SUBJECT: National Park Seminary Rezoning

SUBJECT: National Park Seminary PD-15 Rezoning

PROJECT: National Park Seminary Site-Development Plan
ReZoning Case #G-828

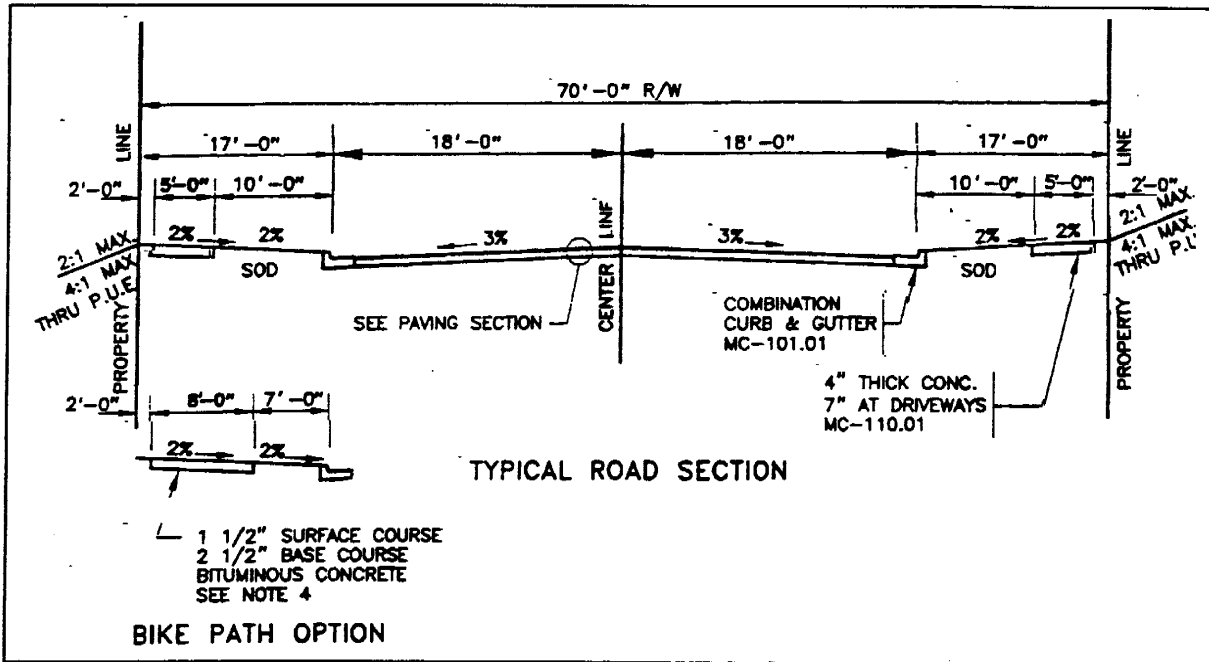
Transportation staff's analysis elaborates on the discussion regarding appropriate right-of-way for Linden Lane. The historic site places constraints on provision of a typical section. Neighborhood groups seek to keep right-of-way and particularly pavement narrow to provide traffic calming. DPW&T staff and M-NCPPC staff are attempting to balance these objectives with the public purpose of a road design that will be safe to use, reasonable to maintain, and calm traffic. Vehicular and pedestrian safety considerations suggest various design alternatives which under discussion and will be resolved in the subsequent reviews. The Green Tape process has facilitated a helpful discussion of this issue earlier than it would have occurred in a standard review. On the following page depictions of typical and proposed sections

are highlighted for informational purposes. Discussion continues and a section will be finalized in the preliminary plan of subdivision review.

The typical road section for a residential primary road anticipates 36' of pavement. An additional 34 feet is needed for offsets, green space and sidewalks.

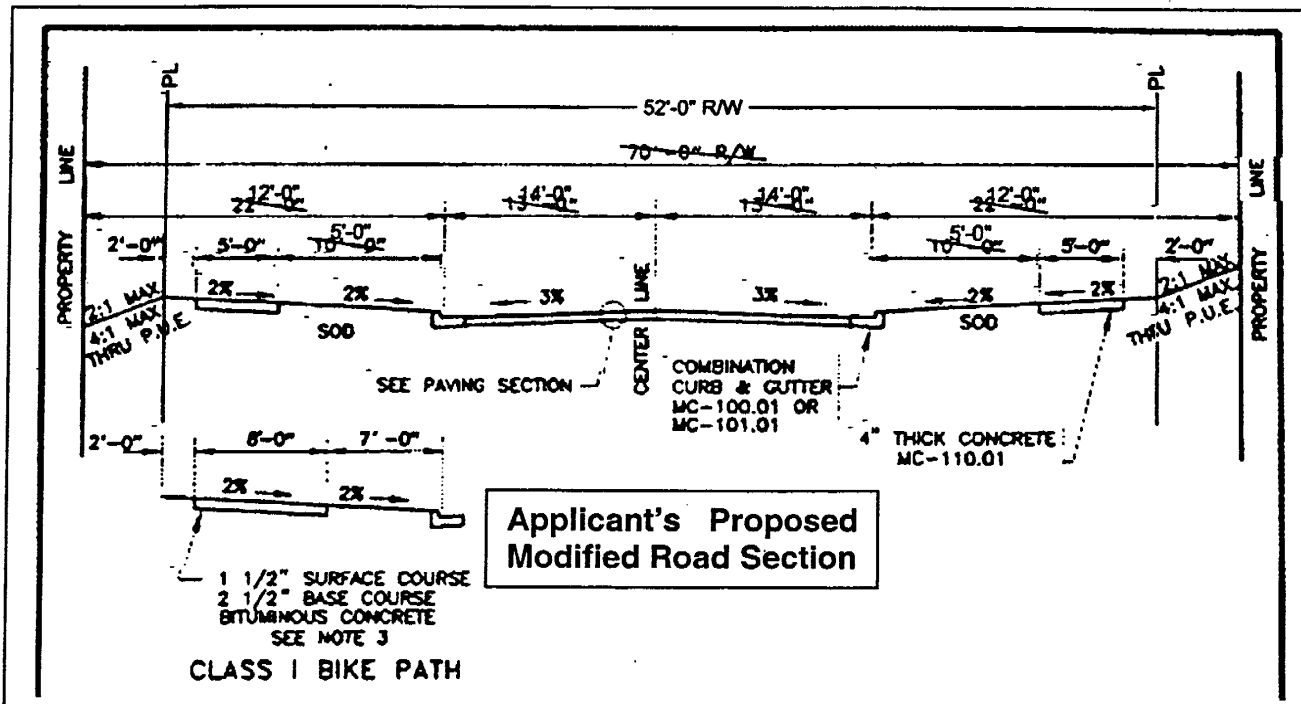
The constraints of the site and development scheme have caused the applicant to request a waiver of this section from the Department of Permitting Services. Technical staff has been involved in this discussion. The applicant proposes reducing the right-of-way from 70' to 52' as shown below. This is accomplished by removing parking from one side of the street and making some other adjustments to area the needed for offsets, green space and sidewalks. At the writing of this report, County staff has indicated support for a 52' section. While the final resolution of this matter will occur in the subsequent review, a shared objective is to make sure vehicular travel lanes and sidewalks are the same in the modified section as they are in a typical section.

⁹ As of the writing of this report, there is agreement on 52' of right-of-way. Specifics will be resolved in subsequent review.
